BAR Meeting  
November 13, 2013

**ISSUE:** Permit to Demolish/Capsulate and Certificate of Appropriateness for an Addition and Alterations and a Waiver of the rooftop HVAC Screening Requirement, Section 6-403(B)(3)

**LOCATION:** 703 South Fairfax Street

**BAR2013-00366 & BAR2013-00367**

Figure 1. Illustrations showing walls proposed to be demolished / capsulated

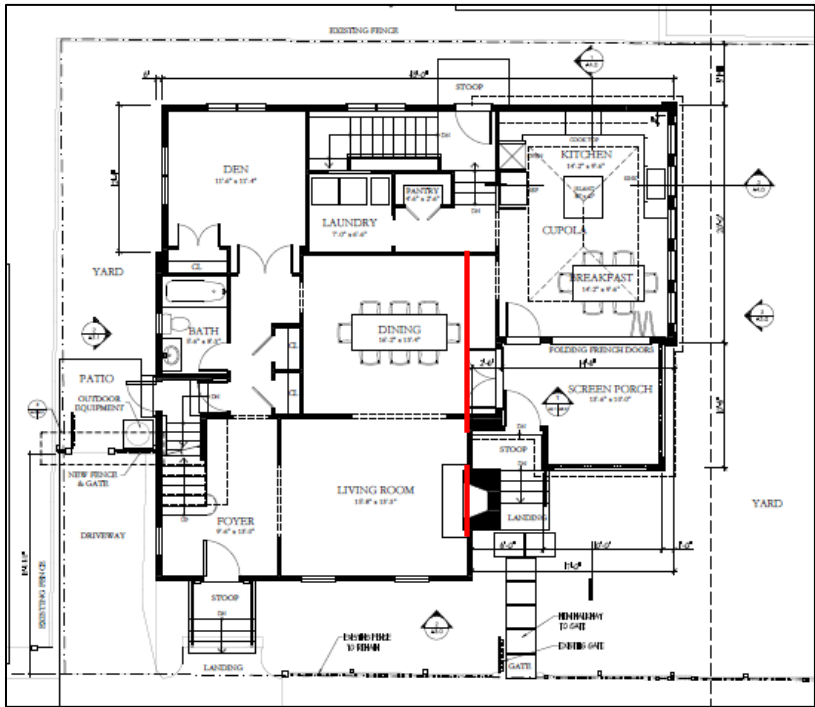
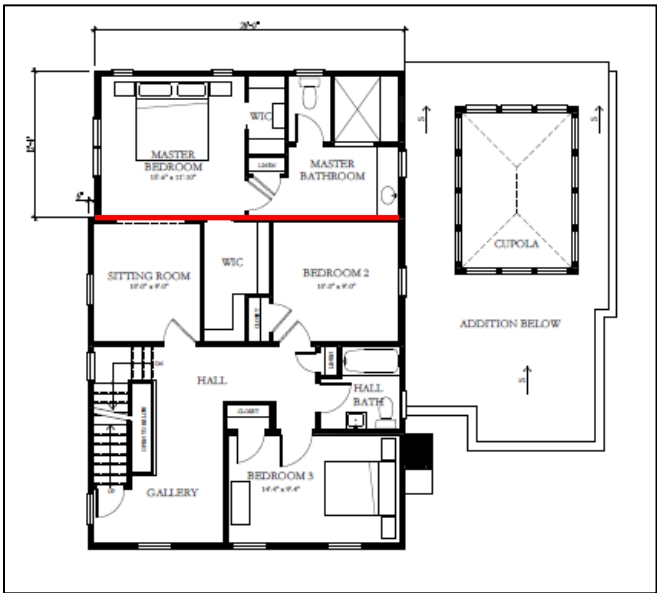
Staff has no objection to the proposed demolition or capsulation and finds the proposed additions to be compatible with the existing building. The scope of the proposed demolition is minimal in scope, contained to contemporary additions or secondary facades, does not remove any portion of the building containing character defining features of uncommon design or historic merit, and does not compromise the integrity of the building as a whole.

The rear enclosed porch to be demolished was constructed c1958, and is not original to the building. As such, staff does not object to its removal. The demolition of the remaining rear exterior wall surface is minimal (250 sq. ft.), as the majority of the rear wall area on the main house proposed to be demolished is capsulated inside the existing one-story enclosed porch, which was previously not visible or subject to BAR's review.

In case of the north (side) addition, the majority of the first floor of this elevation will either be capsulated or demolished for the construction of this addition. The Board regularly approves partial demolition and capsulation to allow for additions when the existing walls or are not particularly unusual or of uncommon construction. Staff does not find that this particular

elevation contains elements, forms or features which define this building’s architectural style or form. Nor does staff find that the proposed additions would diminish the historic integrity or confuse a future observer about the scale and form of the original house.

In staff’s opinion, the Criteria listed above are not met and the Permit to Demolish/Capsulate should be granted.
